Project: 220057 - Heart of the Valley WWTF
801 Thilmany Road
Kaukauna, WI 54130

Potential Change Item #COR015

RFP - 010 - Provide 2 X 2 Lay-In Ceiling Tile in Additional Rooms

SUBJECT: Request for Proposal Number 010 — Provide 2 x 4 Lay-in Ceiling Tile in Rms 101, 103, 104 and 106

Drawing 060-A-1
Spec Section 09-51-00

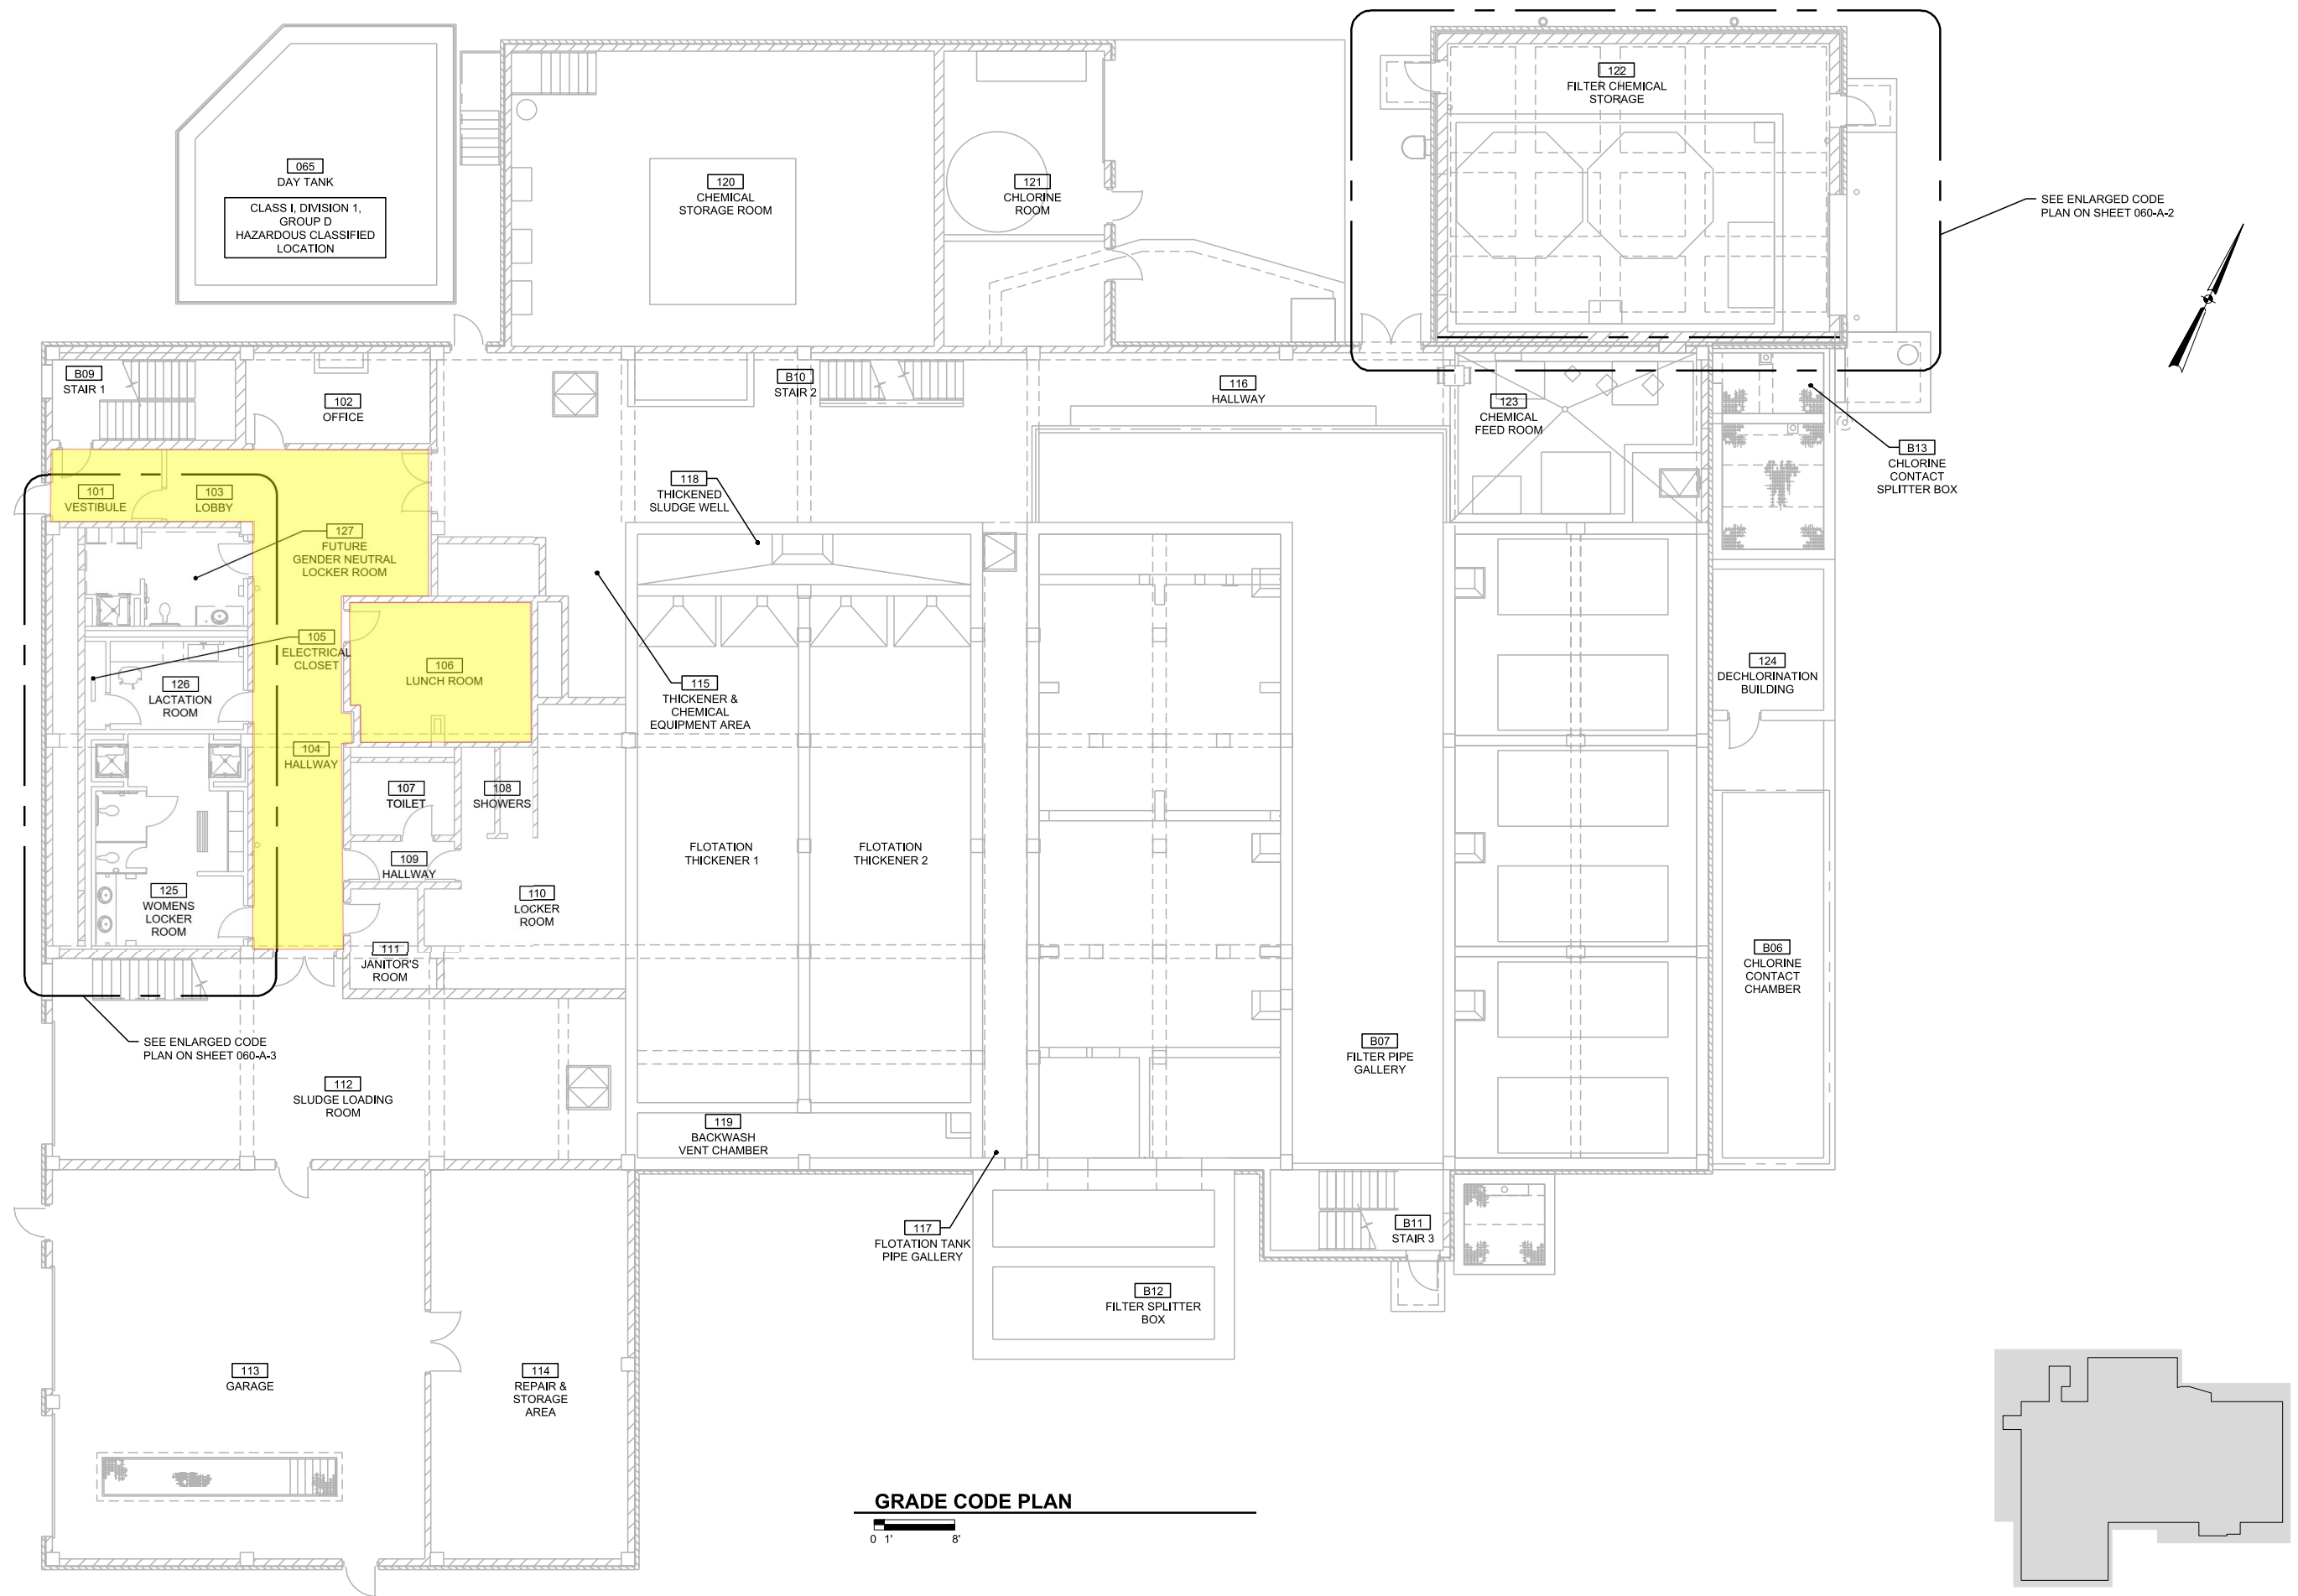
This Request for Proposal (RFP) is being prepared to remove the existing ceiling tile and grid system and install a new 2 x 2 tegular type Lay-in Ceiling Tile (see ACT-1, in Spec 09-51-00) in the following areas: Rm 101-Vestibule, Rm 103 Lobby, Rm 104 Hallway and Rm 106 Lunch Room. See Specification Section 09 51 00 Acoustical Ceilings and the attached drawing showing the locations where the ceiling tile shall be removed and replaced. The lighting in these areas/rooms remains at the existing layout.
